# Citizens Committee to Complete the Refuge

Re: Final Environmental Assessment Cargill, Incorporated Solar Sea Salt System Maintenance and Operations Activities Project (BCDC Permit Application 2021.003.00)

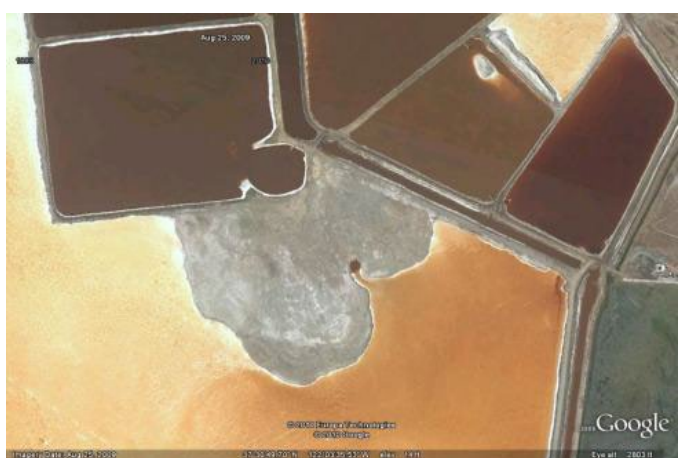
In response to the Recirculated Draft Environmental Assessment, CCCR submitted the photos similar to those provided below, questioning whether the fan of sediment (not salts) depicted within Pond P2-13 is considered a “minor fill.”

The area of sediment deposition in Pond P2-13 did not exist prior to July 2004. By August 2009, a GIS analysis approximated the size of the fan of sediment to cover approximately 18 acres of the pond bottom of P2-13.

Estimates of the areal extent of the fill pad on top of the pond bottom of Pond P2-13 was approximately 18 acres as of 2009, which seems significant. It clearly results in a change in the pond bottom elevation. These do not appear to be deposits of salts, but instead appear to be deposits of sediment that remain in place over significant periods of time.

Is an activity that results in the creation of an 18-acre sediment fan on top of the pond bottom not regulated at all? Will this activity cease or will these sediment fans continue to grow over time?

"Cargill has indicated that these photos do not represent fill. The material on the northwest side of Pond P2-13 consists of mixed sea salts within the pond that were moved around. Cargill manages the distribution of mixed sea salts in the ponds to manage and harvest brine and manage rain water."

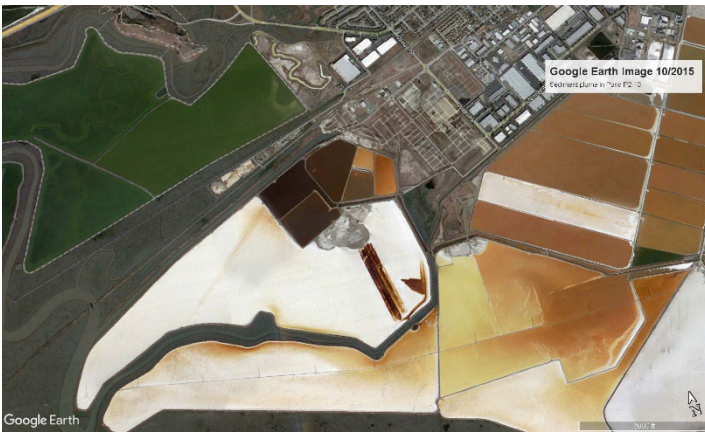
Visual analysis of a Google Earth image from October 2015 indicates this deposition of sediment has continued to grow.

Sediment deposits in Ponds P2- 13 and P2-10

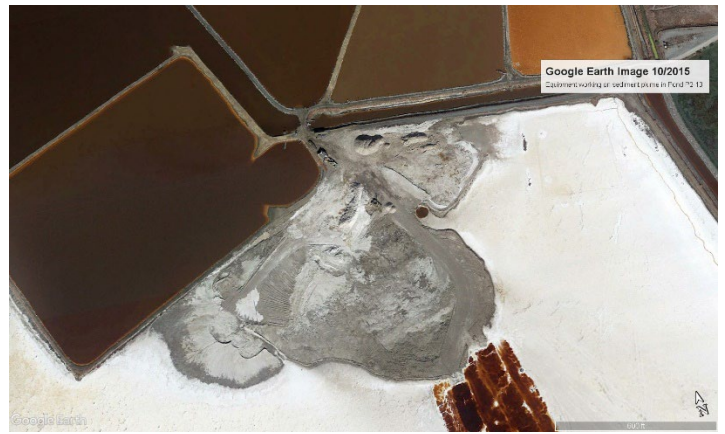
Close-up of the sediment fan in Pond p2-13 (10/2015)

Mounds of sediment can be seen on top of the sediment deposition and equipment working the sediment can be observed in the image.

A similar situation can be observed in Pond P2-10, with sediment depositions on top of the pond bottom visible after 2007.

Does the same response apply for the sediment deposited in pond P2-10?
